SUBJECT: Glasair III Main Landing Gear Side Brace Stud Replacement

MODEL	ASSEMBLY NAME	REVISION	DATE	VOLUME	PAGE
GLASAIR III	SERVICE BULLETIN 137	A	8/1/96		1 of 4

FIGURE (1)

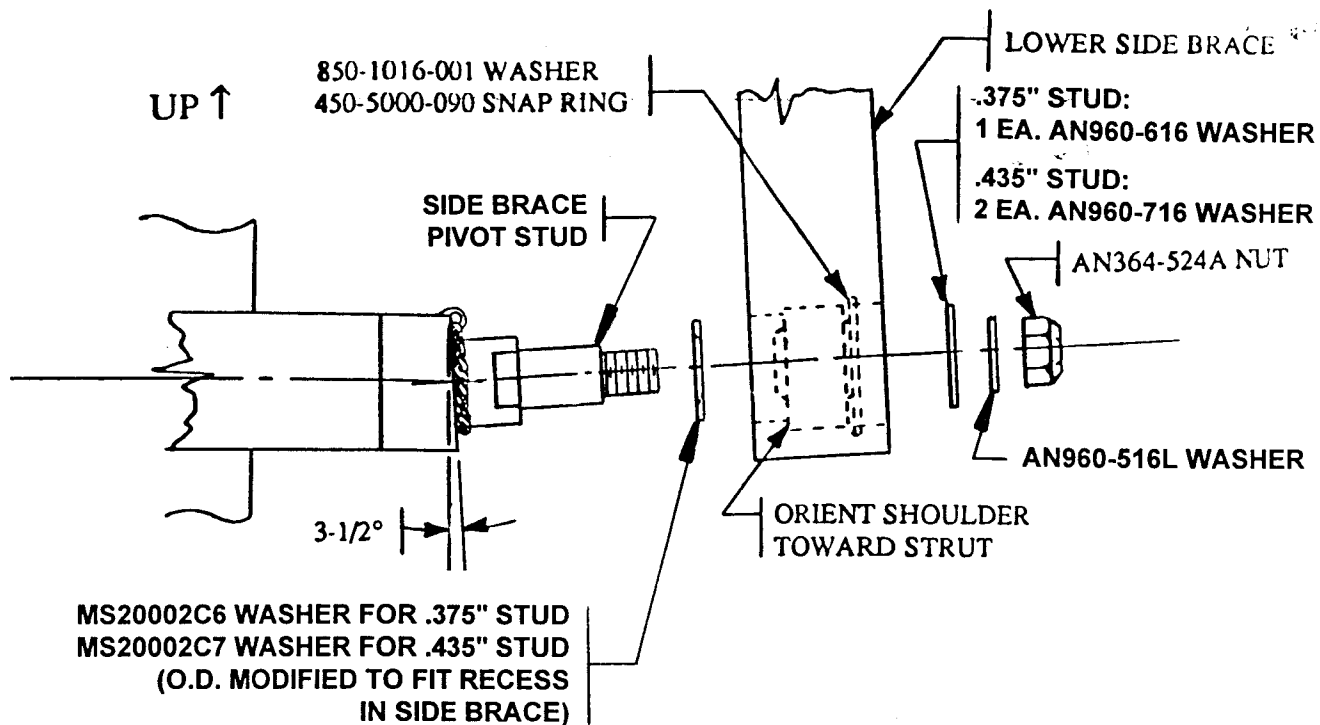
DESCRIPTION: We have received several field reports of side brace studs that have separated from the main gear trunnion cylinder at a groove machined into the base of the stud.

The original side brace attach point on the main gear is a welded-in stud with a diameter of .375" in the area of the bearing shoulder. Removal of the original stud and machining of a threaded boss will provide a means for the installation of one of two sizes of heat-treated replacement studs made of stronger material.

REQUIRED ACTION: Within the next 25 hours in service, cut off the original .375" diameter stud and machine the side brace saddle to a 3-1/2° angle. Drill and tap the existing side brace stud pilot hole (.510" Ø) for 5/8-18 threads. A lock wire hole (3/32" Ø) should be machined at a convenient location. All affected machined surfaces must then be primed for corrosion protection. Apply a thread adhesive to the threads, thread in the P/N 353-5133-003 (.435" diameter) or P/N 353-5133-009 (.375" diameter) stud and torque it to 1,100-1,300 inch-pounds. Secure the stud with .040" lock wire. Use a countersunk washer with the countersunk side against the radius at the base of the stud shank, as shown in figure (1).

FIGURE (2)

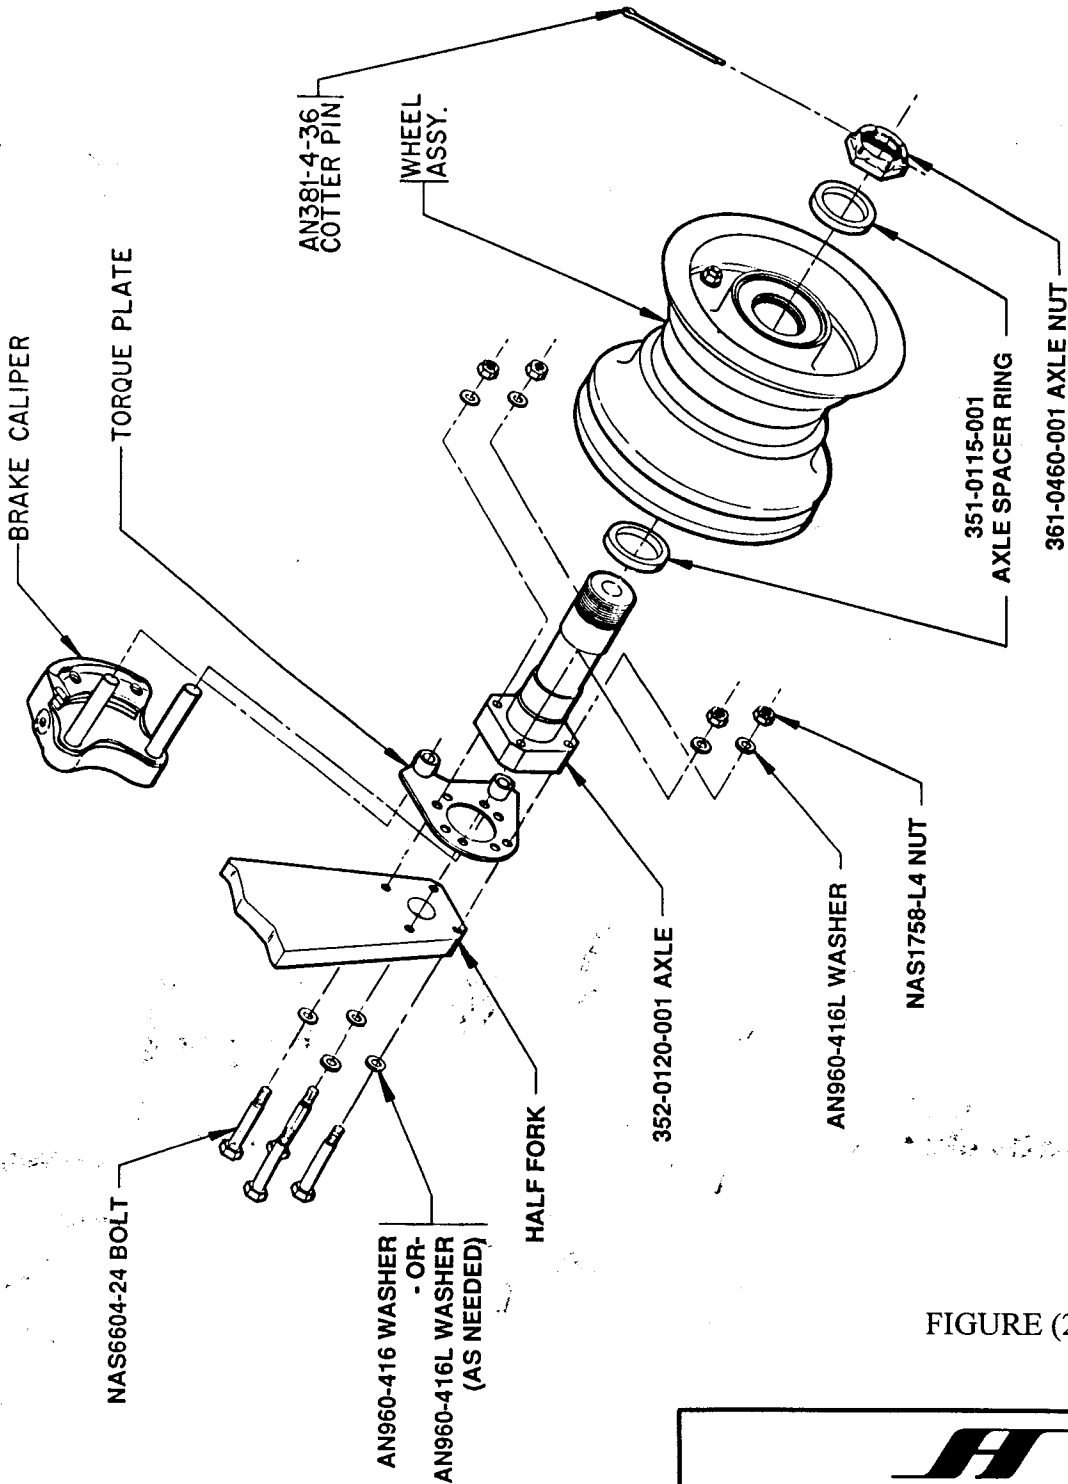
RECOMMENDED ACTION: For an additional \$20.00 charge (\$75.00 after the October 31, 1995, deadline; the price includes parts), Stoddard-Hamilton can also upgrade your axle bolts as mentioned in Service Bulletin #126. Please specify this with the work request attached to your struts if you desire.

AXLE BOLT REPLACEMENT INSTRUCTIONS: In order to install the higher strength NAS6604-24 bolts, remove the existing AN4H13A bolts connecting the axle to the half fork. Drill out the threads with a .250" diameter drill. After each hole is drilled, prime the bare metal inside each hole with an epoxy primer. Install the torque plates and axles using the NAS6604-24 bolts, AN960-416L washers, and NAS1758-L4 nuts, as shown in Figure (2).
